Planning Department Brennon Williams, Director

Site: La Cuentista Unit 2 (D10E002B)

Re: Inspection 8/19/2021 & 8/26/2021

HOA Unit 1 Pond

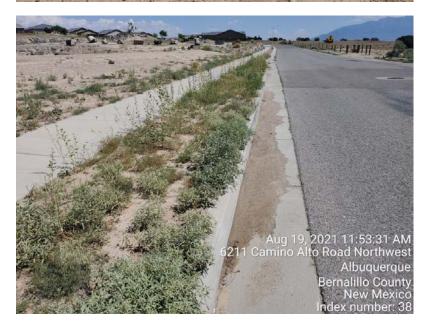
The bottom of the pond received a lot of water an appears to have sufficient vegitation to satisfy the strict interperitation of the final stabilization criteria.

Ortav Albuquerque The pond side slopes are mostly bare dirt and will remain erosive until they are stabilized with rock armoring. The natural undisturbed condithion of the land is flat and not very erosive, but the steep slopes require a lot more cover to stabilize.

La Cuentista, Summary of Stabilization Inspection

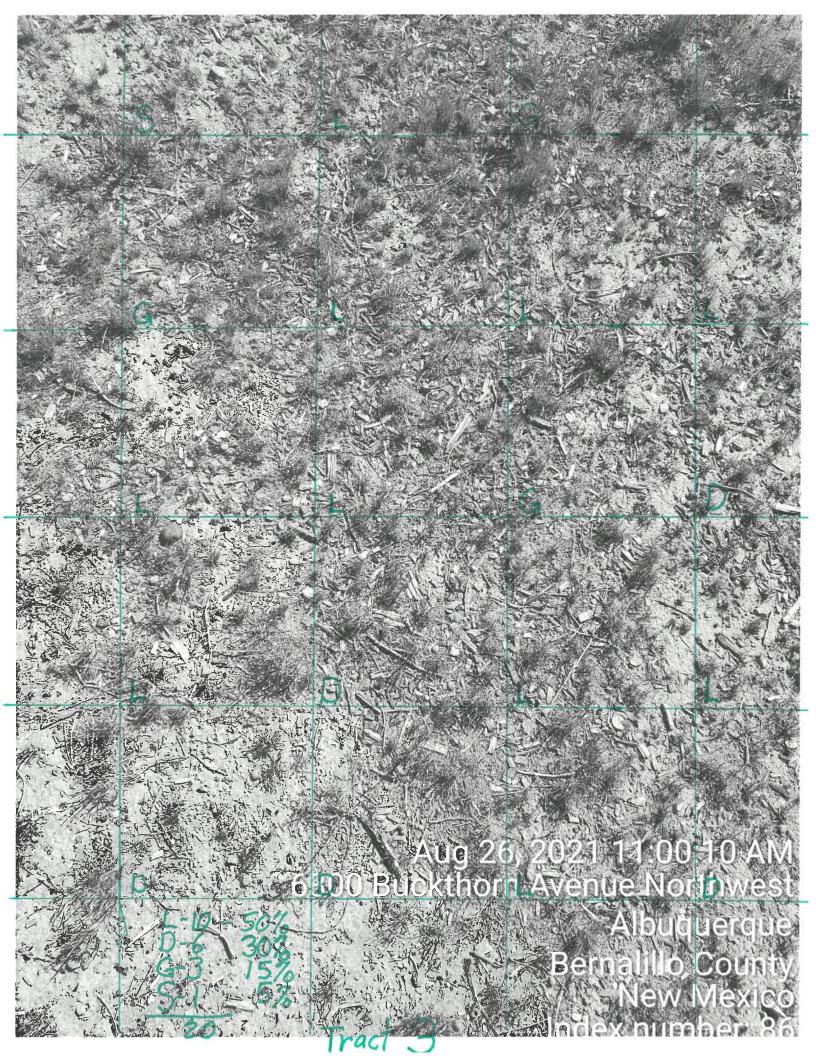
The minimum replacement density is (70% of the natural density) 14% and 23% to satisfy the strict and loose interpretations of 2.2.14b.i respectively.
